Park Bangladesh Company Ltd

Plot# 94-95, Sector# 03, Karnaphuli EPZ, North Patenga, Chattogram

13 September 2023

Observations

Observation: Building-1 (Main Building)

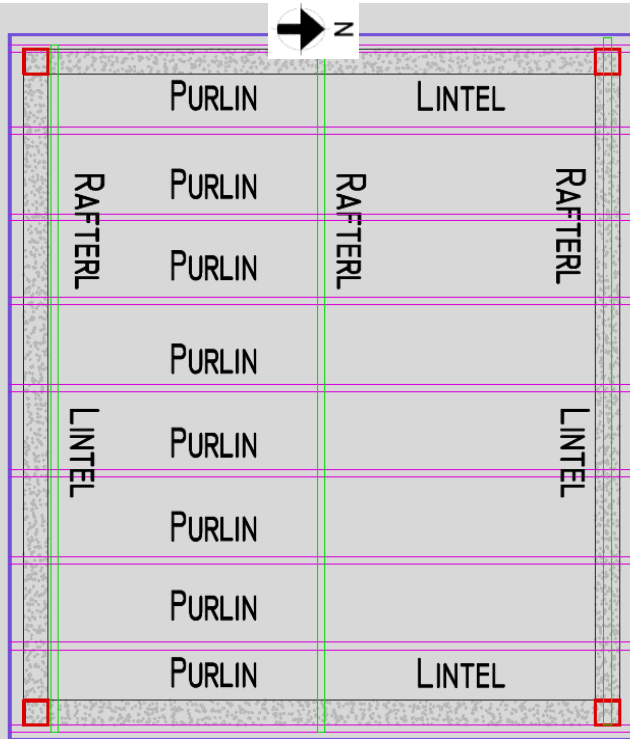
Dampness and leaked rainwater downpipe close to the columns were observed. Building engineer is required to repair the leaked downpipe and repair the dampness.

Rafter & Purlin layout plan

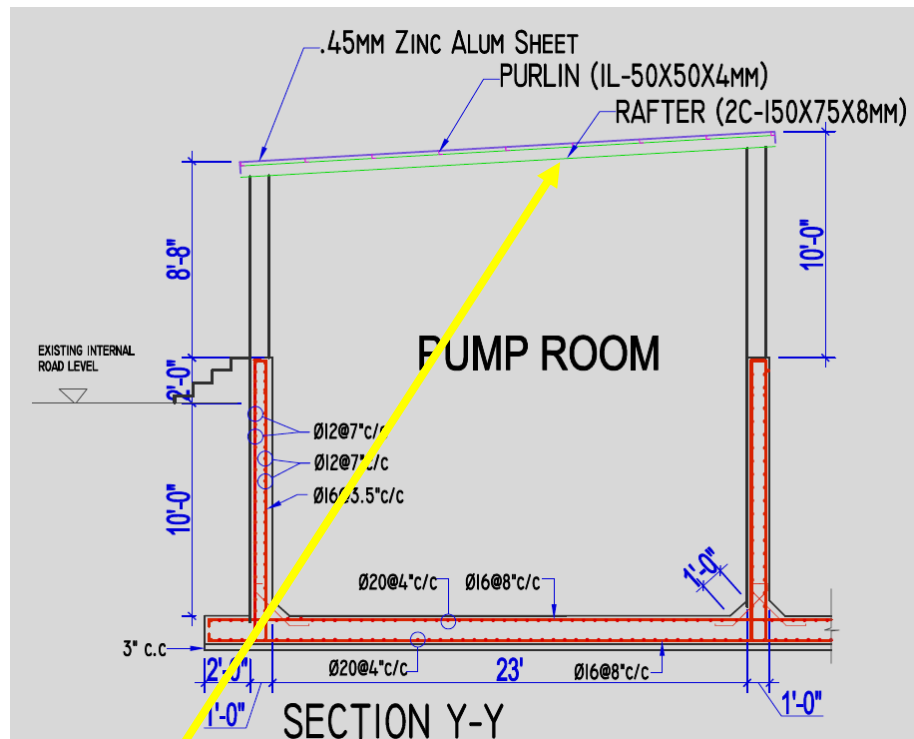
Rafter section did not match with on site condition. In drawing 'I' section was shown, but 'C' channel was provided on site.
